PACKAGE NO: RSTDSP/NKH/01

TITLE : GENERAL ARRANGEMENT DRAWING OF SLUDGE STORAGE YARD FOR 5 MLD STP, AT NOKHA, BIKANER
SHEET NO.- 1 of 1

TITLE : STRUCTURAL DRAWING OF SLUDGE STORAGE SHED FOR 5 MLD STP, AT NOKHA (SHEET.-1 of 2)

TITLE : STRUCTURAL DRAWING OF SLUDGE STORAGE SHED FOR 5 MLD STP, AT NOKHA (SHEET.-2 of 2)

PLAN

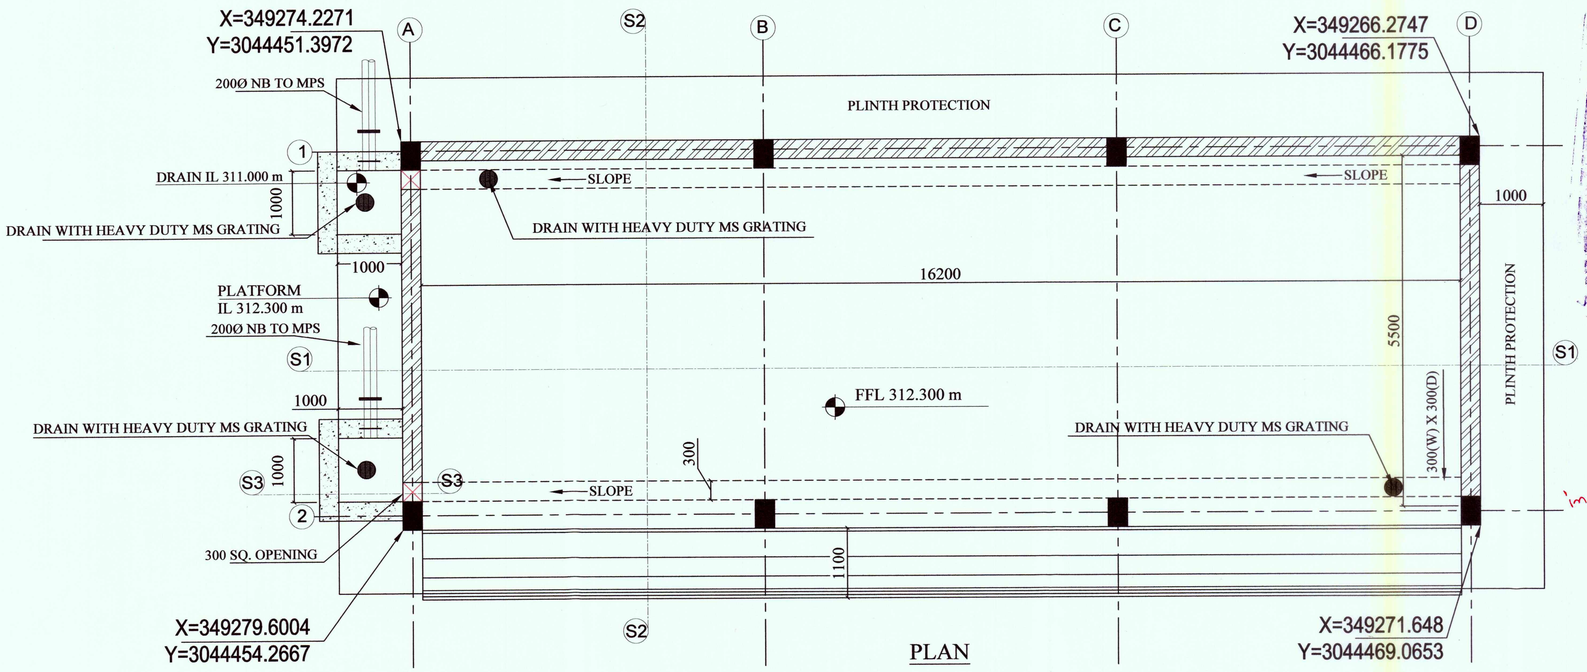
Mechanical scrapper may be proposed to install in this yard by contractor for overturning of sludge

SECTION 'B-B'

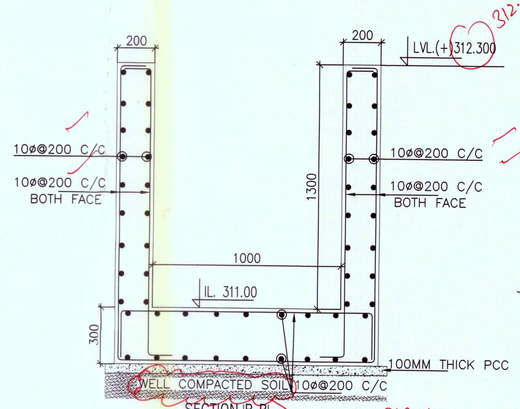
NATURAL EARTH OR PLUM CONCRETE AS PER CA
